SUBJECT: ISSUANCE OF AMENDMENT NO. 49 TO FACILITY OPERATING LICENSE
NO. R-28 UNIVERSITY OF MICHIGAN FORD NUCLEAR REACTOR
(TAC NO. MD1670)

AMENDMENT TO FACILITY OPERATING LICENSE

Amendment No. 49
License No. R-28

SAFETY EVALUATION BY THE OFFICE OF NUCLEAR REACTOR REGULATION

Figure 6.1 Organization Chart for the Ford Nuclear Reactor

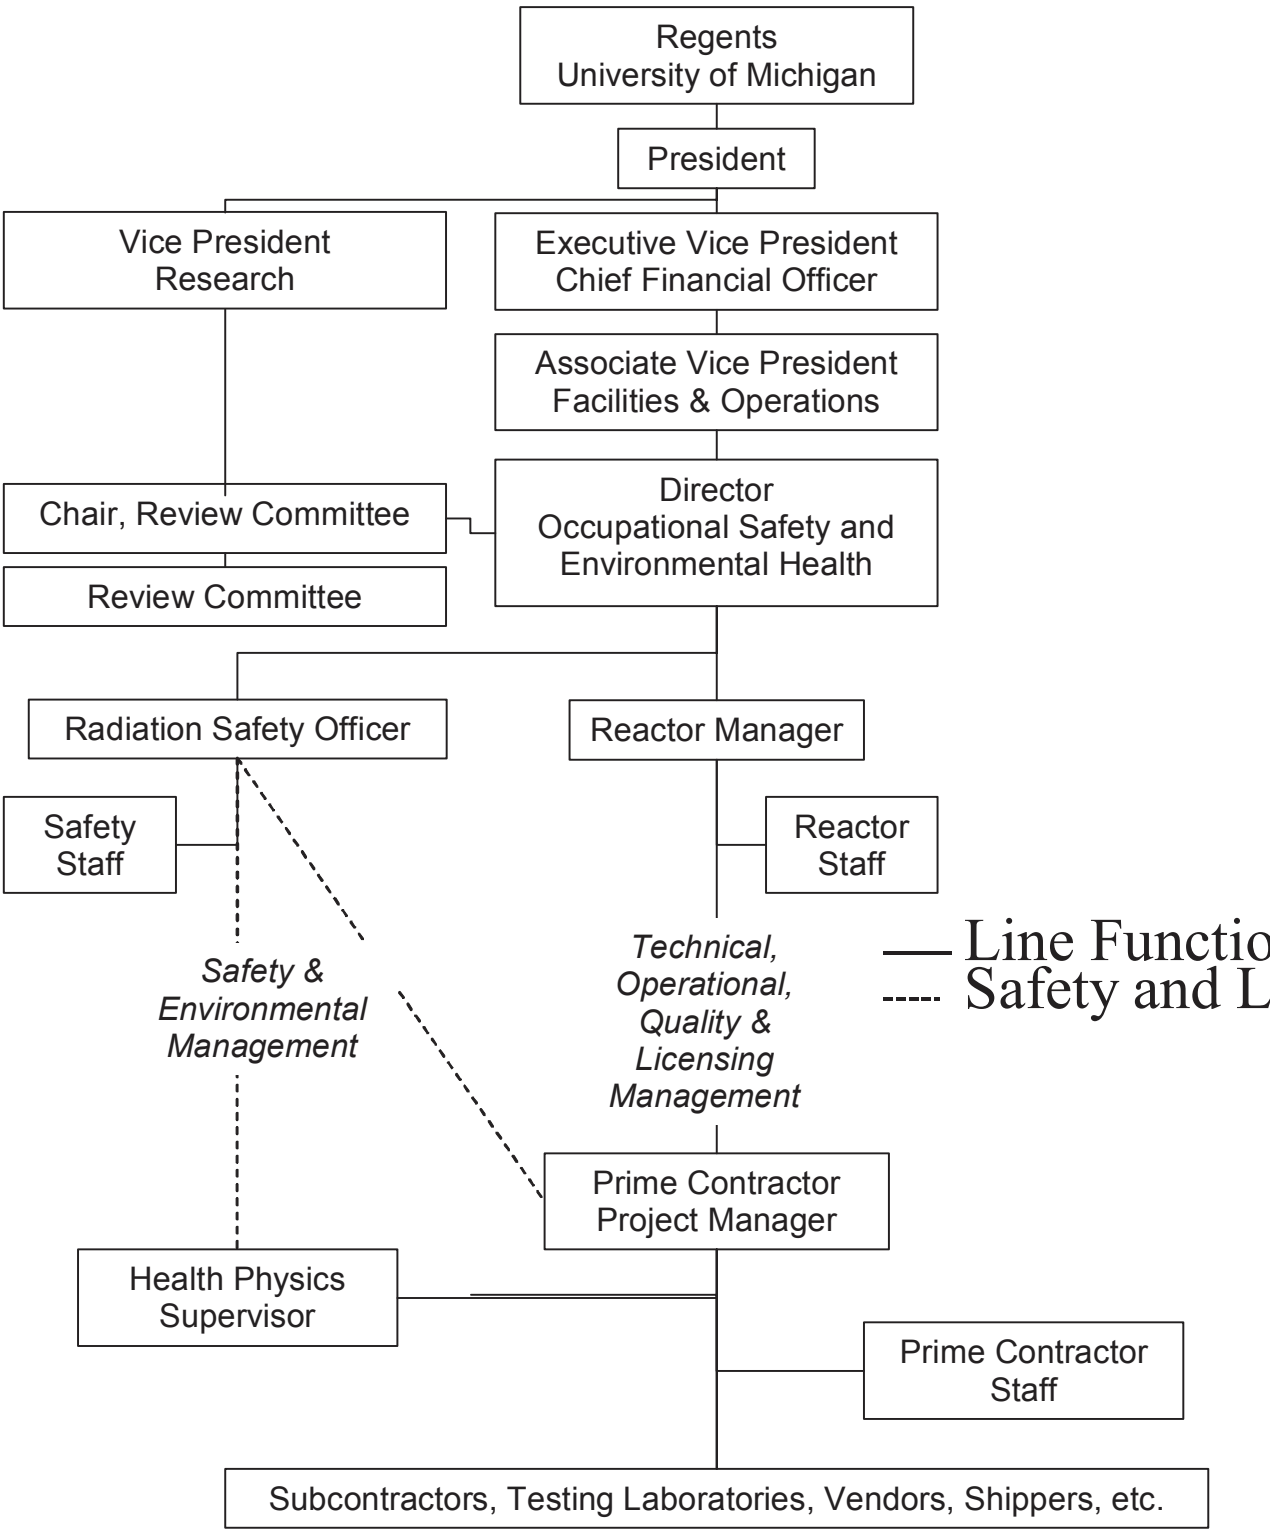
1. The organizational structure of the University of Michigan relating to the Ford Nuclear Reactor (FNR) shall be as shown in Figure 6.1.
2. The Reactor Manager shall be responsible for the safe decommissioning of the Ford Nuclear Reactor. He shall be responsible for assuring that all activities are conducted in a safe manner within the limits prescribed by the facility license, including the technical specifications and facility procedures. During periods of his absence, the responsibilities of the Reactor Manager may be delegated to an individual who satisfies the qualification requirements for the Reactor Manager. *

For the years of licensed activities at FNR, the Director of Michigan Memorial Phoenix Project (MMPP) was responsible for the facility's operating license. The Regents of UM are responsible for overall planning, managing, and financing the decommissioning of the FNR. The bylaws of the Board of Regents specifically assign responsibility for the decommissioning to the Executive Vice President and Chief Financial Officer. The Executive Vice President has established, through the Associate Vice President for Facilities and Operation, a project organization to oversee the decommissioning of FNR. The licensee has proposed changing TS 6.1, Organization, to reflect a new organizational chart for the FNR decommissioning project which includes the following key management positions:
